2018 Basin Boundary Modifications - Final

Basin(s): 1-004 SHASTA VALLEY

Requesting Agency: Siskiyou County Flood Control and Water Conservation District

DWR Final Decision: Approve

Basin(s): 5-021.58 SACRAMENTO VALLEY – WEST BUTTE; 5-021.59 SACRAMENTO VALLEY – EAST BUTTE

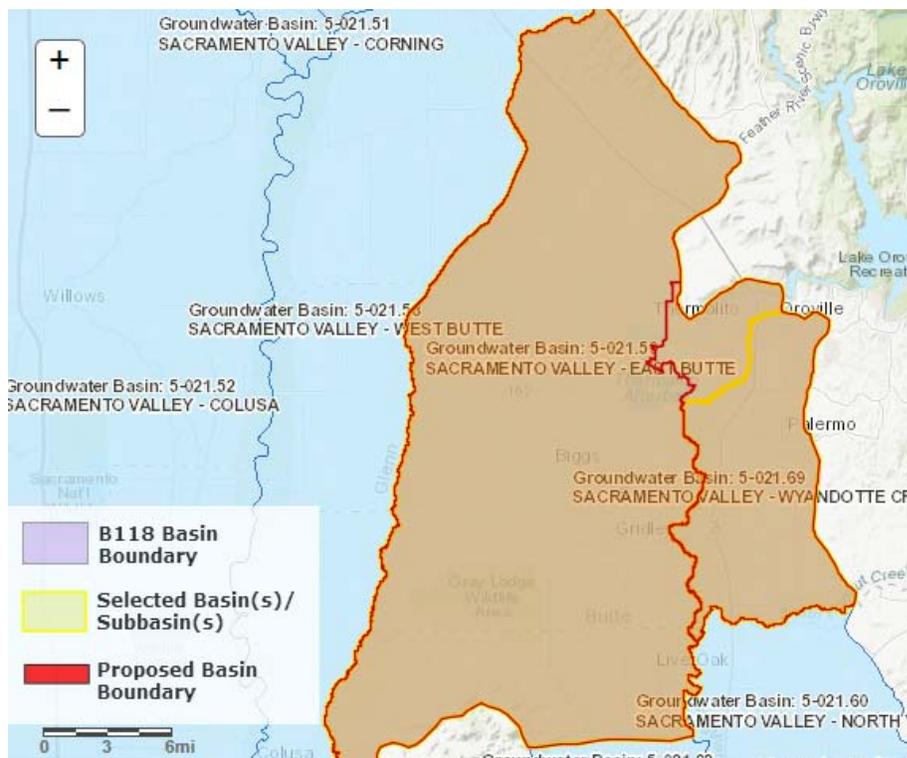
Agency Description: Move
730 acres of
RD1004 land from
East Butte to the
West Butte
Subbasin.

Basis for Decision: The basin boundary modification revises the southern shared boundary of West Butte and East Butte subbasins to align with Reclamation District 1004's jurisdictional boundaries. The revision would put Reclamation District 1004 entirely within the West Butte subbasin. This modification correlates with another request submitted by Butte County Department of Water and Resource Conservation. The request meets regulatory requirements.

Basin(s): 5-021.59 SACRAMENTO VALLEY – EAST BUTTE; 5-021.69 SACRAMENTO VALLEY – WYANDOTTE CREEK

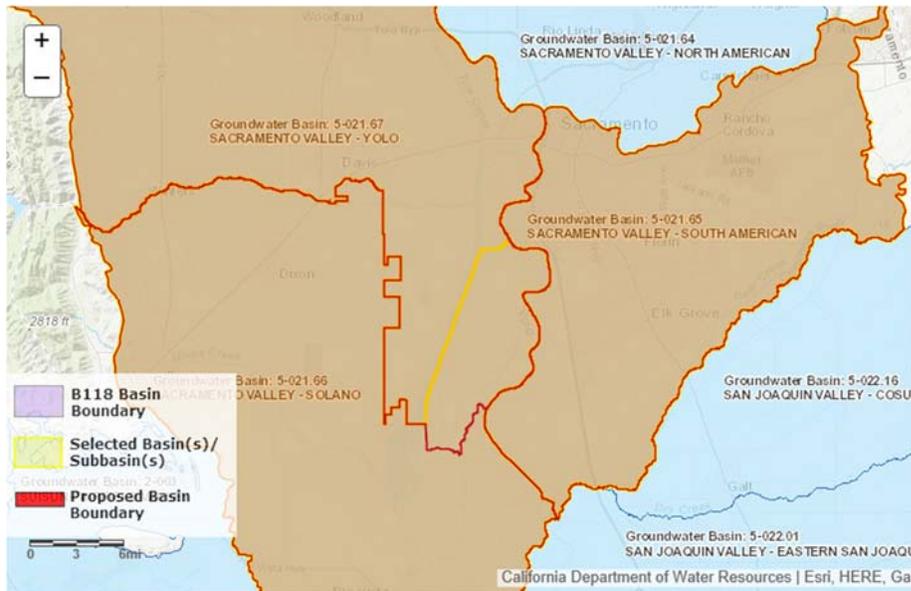
Agency Description: Adjust the boundaries of the Wyandotte Creek subbasin to include the City of Oroville and surrounding urbanized areas.

Basis for Decision: The basin boundary modification revises the boundary between the Wyandotte Creek subbasin and the East Butte subbasin so that the City of Oroville and the Thermalito Water and Sewer District are entirely within the Wyandotte Creek subbasin. The proposed boundary generally follows the Feather River and eastern extent of the Thermalito Afterbay. Six letters of support are associated with the request. The request meets regulatory requirements.

Basin(s): 5-021.65 SACRAMENTO VALLEY – SOUTH AMERICAN; 5-021.66 SACRAMENTO VALLEY – SOLANO; 5-021.67 SACRAMENTO VALLEY - YOLO

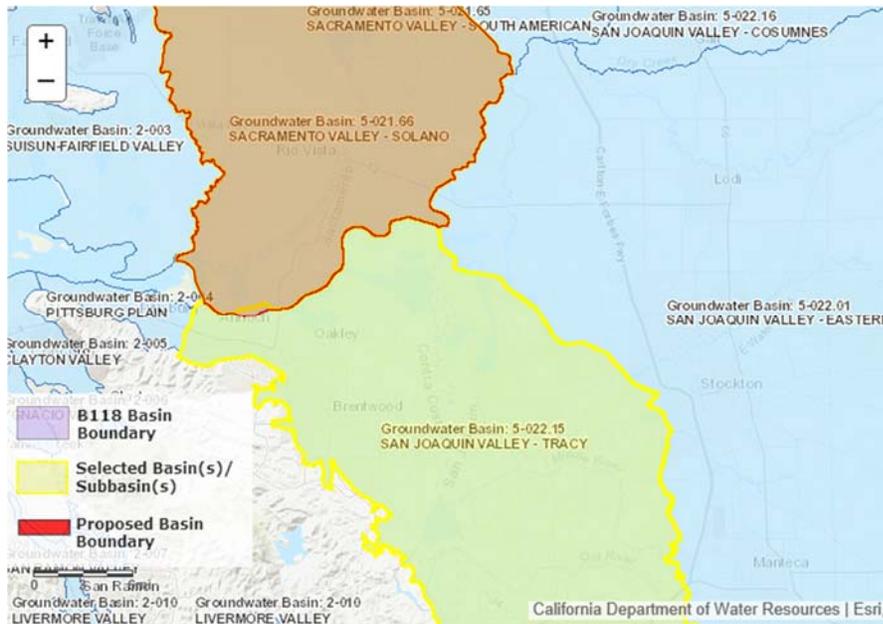
Agency Description: Modification to Incorporate RD 150 and RD 999 into the Yolo Subbasin

Basis for Decision: The basin boundary modification revises the internal boundary line between Yolo and Solano subbasins to bring Yolo County Reclamation Districts 150, 307, and 999 into the Yolo Subbasin. Five letters of support are associated with the request. Two public comments (support) were submitted on the draft decision to approve the modification. The request meets regulatory requirements.

Basin(s): 5-021.66 SACRAMENTO VALLEY – SOLANO; 5-022.15 SAN JOAQUIN VALLEY - TRACY

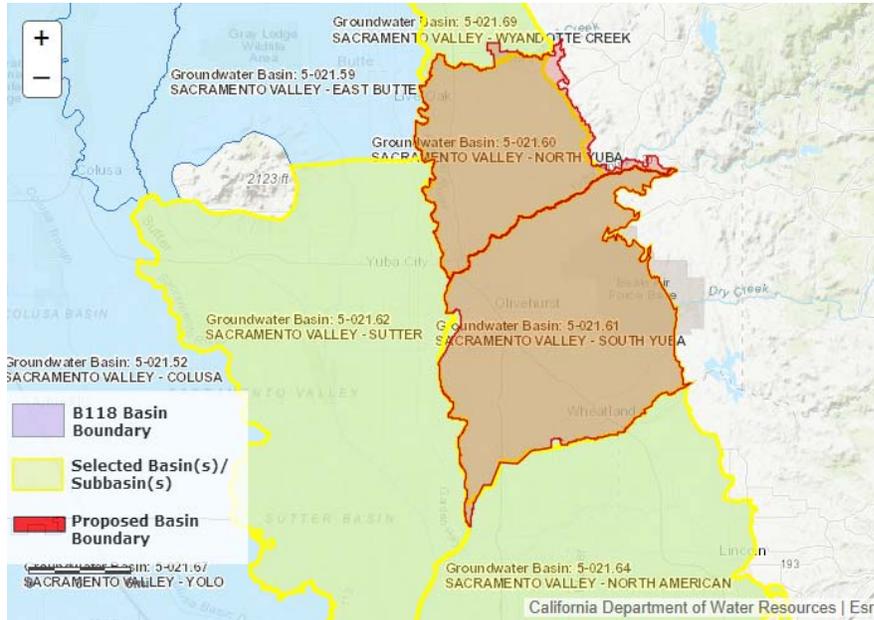
Modification to shift <600 acres of water and land from the Tracy subbasin to the Solano subbasin.

Basis for Decision: This basin boundary modification revises the existing boundary defined by waterway to the shared county line with Contra Costa and Sacramento. The modification shifts an approximately 600-acre area in the existing Tracy subbasin to the Solano subbasin. Seven letters of support are associated with the request. This request meets regulatory requirements.

Basin(s): 5-022.01 SAN JOAQUIN VALLEY - EASTERN SAN JOAQUIN; 5-022.15 SAN JOAQUIN VALLEY - TRACY

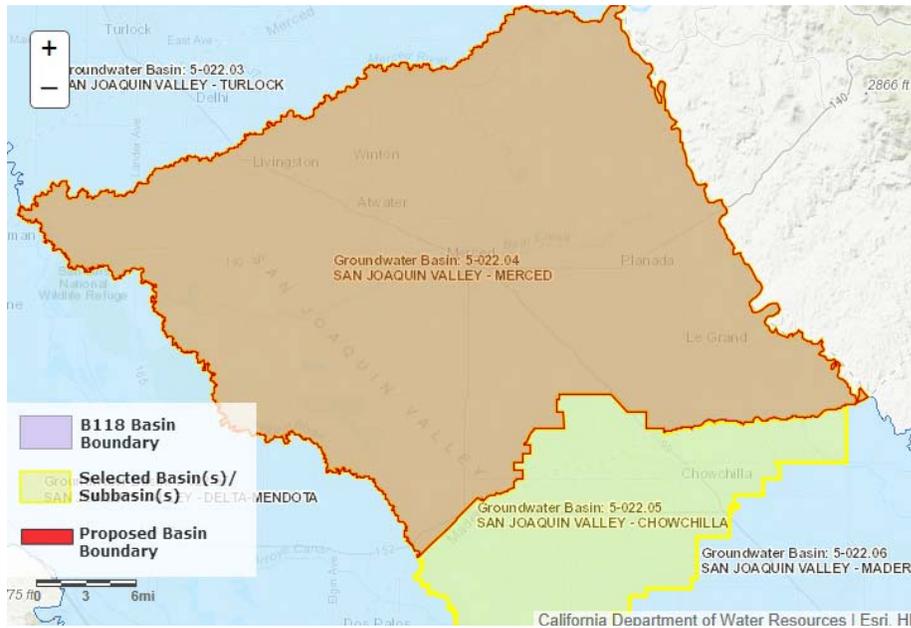
Agency Description:
Jurisdictional request to align the Eastern San Joaquin and Tracy Subbasins with the City of Lathrop's city limit.

Basis for Decision: This basin boundary modification revises the Eastern San Joaquin and Tracy subbasin boundaries to align with the City of Lathrop's city limits. The modification places the City of Lathrop entirely within the Tracy subbasin. Four letters of support and one letter of opposition are associated with the request. The modification request meets regulatory requirements.

Basin(s): 5-022.05 SAN JOAQUIN VALLEY – CHOWCHILLA; 5-022.04 SAN JOAQUIN VALLEY - MERCED

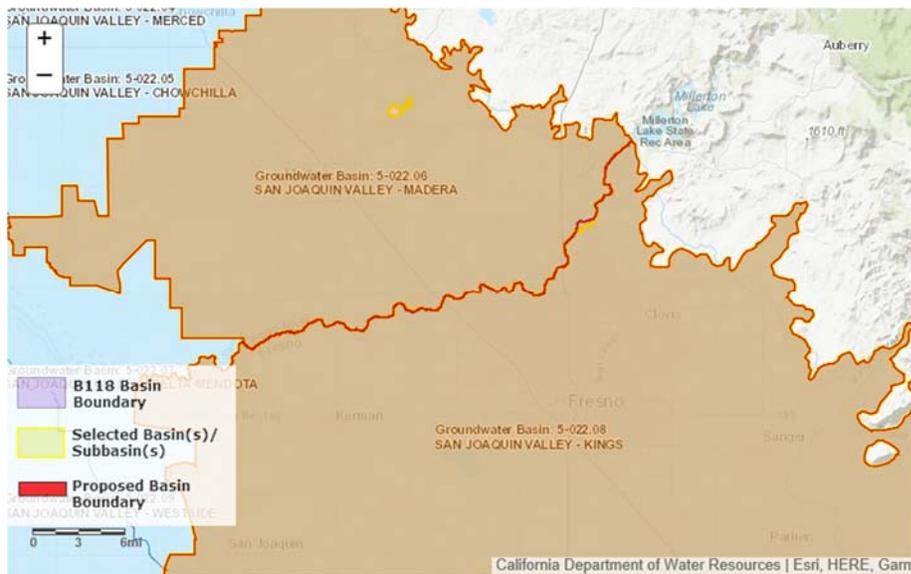
Agency Description: Adjust Chowchilla subbasin to a more up-to-date representation of the Madera County boundary.

Basis for Decision: The basin boundary modification revises the easterly portion of the Chowchilla Merced subbasins boundary to follow the Madera- Merced County line. Four letters of support are associated with the request. The request satisfies regulatory requirements for an internal jurisdictional modification.

Basin(s): 5-022.06 SAN JOAQUIN VALLEY – MADERA; 5-022.08 SAN JOAQUIN VALLEY - KINGS

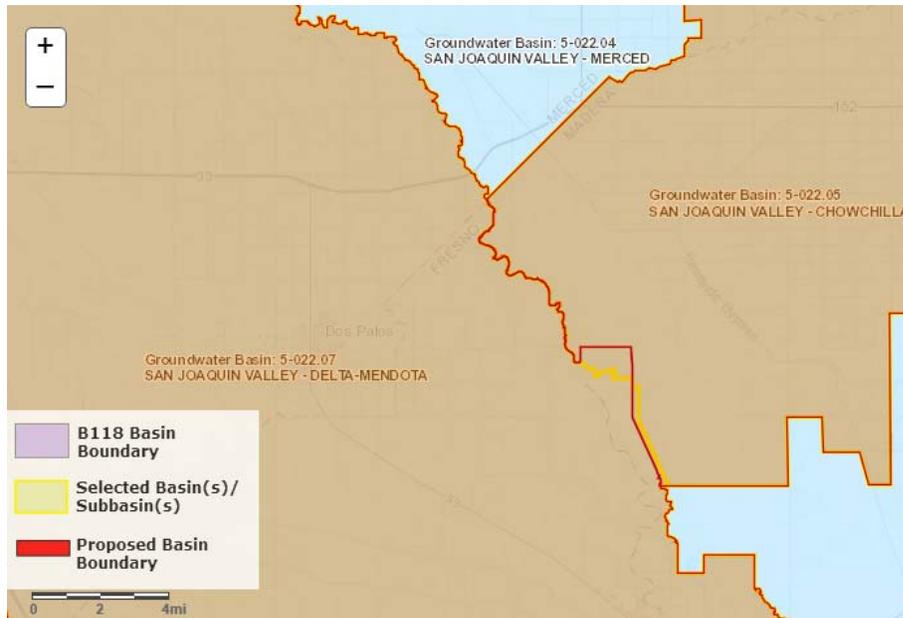
Agency Description: Jurisdictional modification to align the Madera basin with the County line. Scientific request to include Madera Lake in the Madera subbasin.

Basis for Decision: The basin boundary modification revises the Madera and Kings subbasins boundary to follow the Madera- Fresno County line. The modification also includes Madera Lake within the Madera subbasin. The requesting agency supplied sufficient information to support the modification. Several letters of support are associated with the request. The request meets regulatory requirements.

Basin(s): 5-022.07 SAN JOAQUIN VALLEY - DELTA-MENDOTA: 5-022.05 SAN JOAQUIN VALLEY - CHOWCHILLA

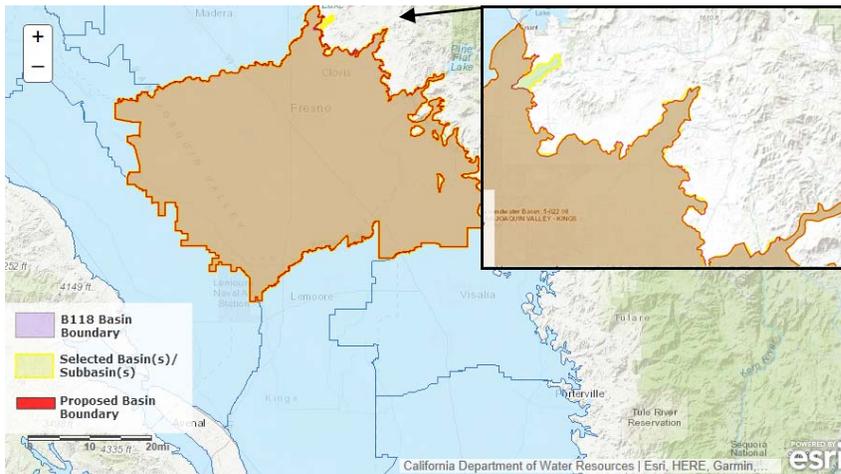
Agency Description: Boundary modification between Delta-Mendota and Chowchilla subbasins following the boundaries of Triangle T WD and Clayton WD.

Basis for Decision: The basin boundary modification would revise a portion of the shared boundary between the Chowchilla and Delta-Mendota subbasins to align with the jurisdictional boundaries of Triangle T Water District and Clayton Water District. Three letters of support and one letter of opposition are associated with the request. This request meets regulatory requirements.

Basin(s): 5-022.08 SAN JOAQUIN VALLEY - KINGS

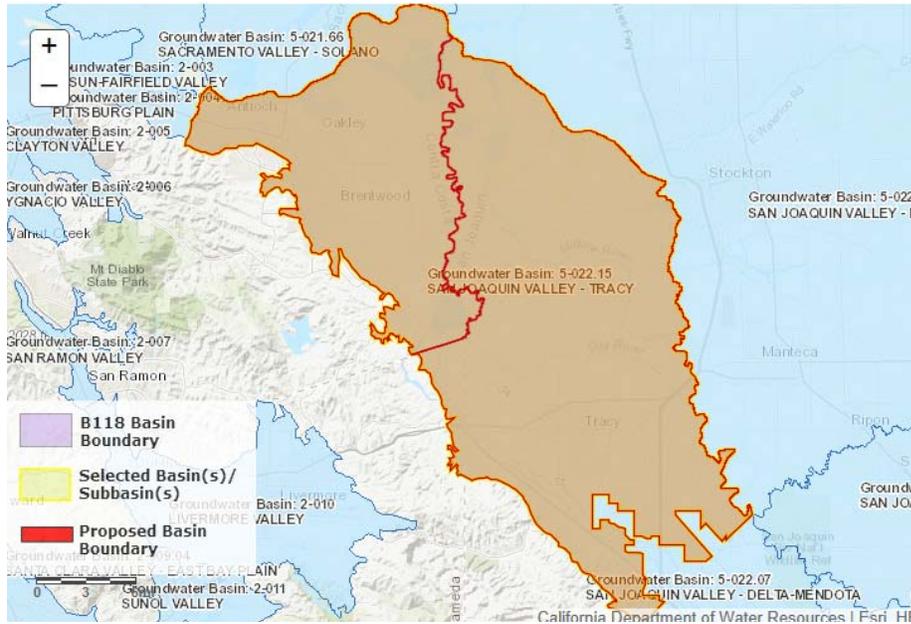
Agency Description:
Modify the eastern
boundary of the Kings
subbasin such that the
eastern boundary more
closely aligns with the
alluvial/bedrock
boundary.

Basis for Decision: The basin boundary modification revises the northeastern external boundary of the Kings subbasin to more accurately follow mapped contacts between alluvial units and non-alluvial geologic units. The requesting agency provided sufficient scientific rationale and utilized a qualified map for the boundary revision. This request meets regulatory requirements.

Basin(s): 5-022.15 SAN JOAQUIN VALLEY - TRACY

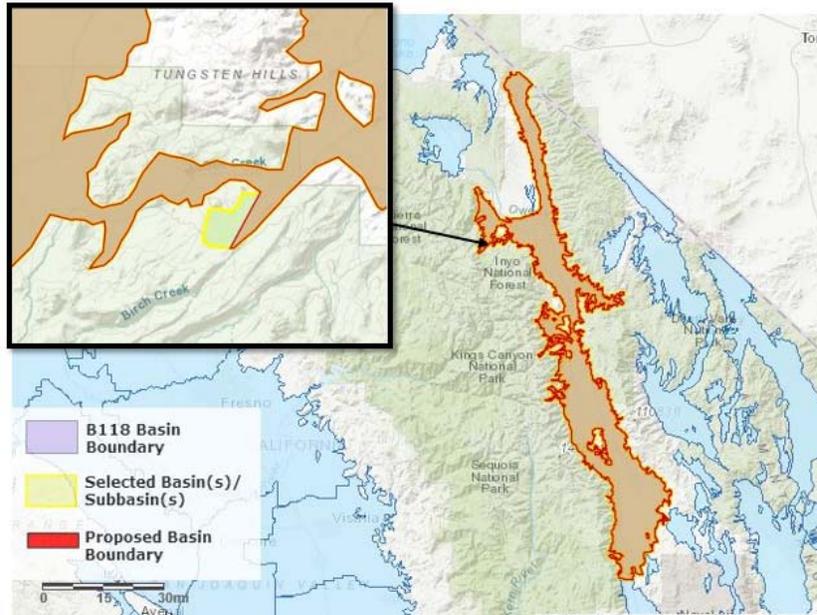
Agency Description: Subdivide Tracy Subbasin at the Contra Costa County line.

Basis for Decision: The basin boundary modification subdivides the Tracy subbasin along the Contra Costa County line. Multiple outreach meetings were held throughout the basin, and letters were delivered to water systems and local agencies. The requesting agency obtained the required three-quarters support from local agencies and public water systems for a jurisdictional subdivision. The request satisfies regulatory requirements for a jurisdictional subdivision.

Basin(s): 7-012 WARREN VALLEY; 7-062 JOSHUA TREE

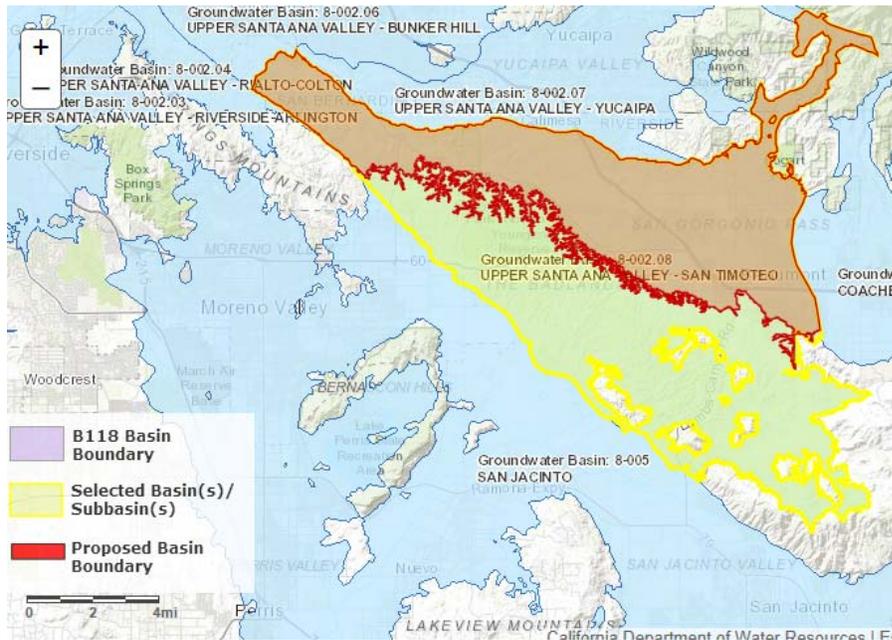
Agency Description: Bring the eastern basin boundary into alignment with the written description of the Warren Valley Basin provided in Bulletin 118 (2003).

Basis for Decision: The basin boundary modification revises the basin boundary into alignment with the Warren Valley basin description published in Bulletin-118 (Update 2003). The modification aligns the western boundary of the Joshua Tree basin with the geographic location of the Yucca barrier, a feature that affects groundwater flow. The requesting agency presented sufficient scientific rationale to justify modifying the boundary, including technical studies and Bulletin-118 basin descriptions. Two letters of support are associated with the request. The request meets regulatory requirements.

Basin(s): 8-002.08 UPPER SANTA ANA VALLEY – SAN TIMOTEO

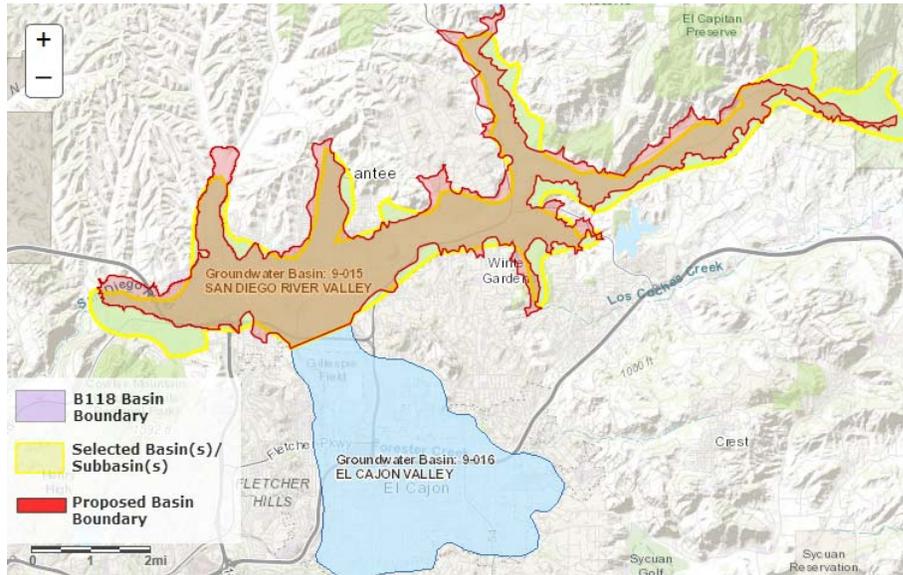
Agency Description: Basin boundary modification based on scientific justification to better represent aquifer conditions.

Basis for Decision: The basin boundary modification removes areas of low permeability, well-consolidated bedrock from the basin. The revised basin boundary follows geologic contacts of alluvium and bedrock using a qualified geologic map. The request includes sufficient supporting information for delineating the bedrock and alluvial areas and meets regulatory requirements.
